Taratex Fashion Ltd. (10071)

17.AUGUST.2014

ACCORD on Fire and Building Safety in Bangladesh

1st Priority 2 Concern

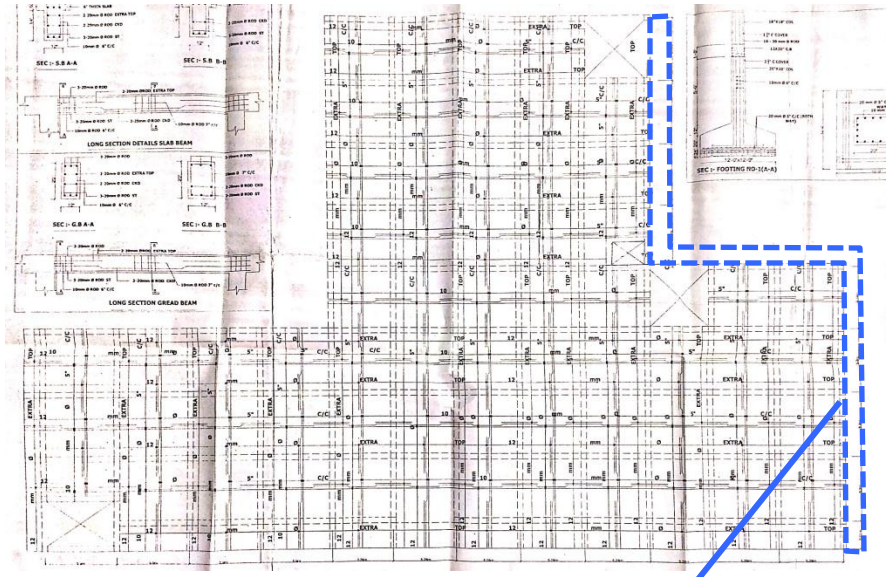
Beam layout plan and some beam details are missing in the structural drawings.

Beam layout plan is required and beam details need to be revised.

1st Priority 2 Concern

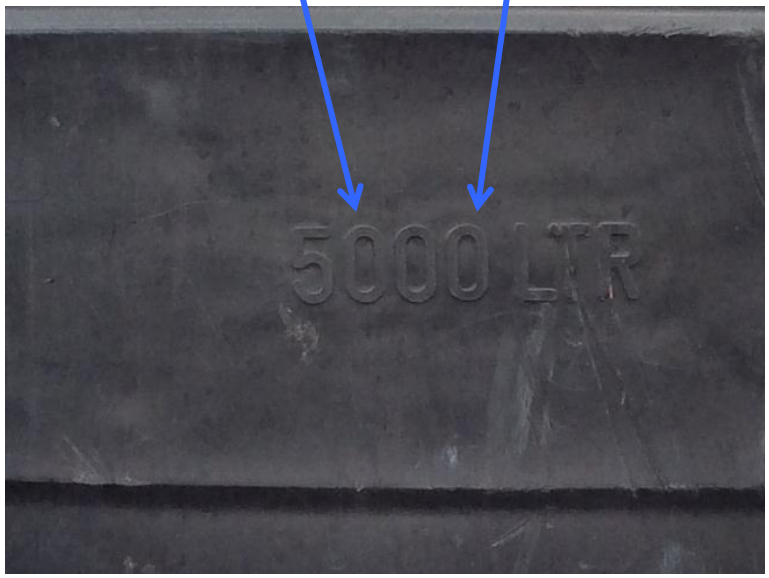
There are cantilevered slabs noted in area shown on the left picture. These do not match the structural drawings.

Floor plans and slab details need to be revised.
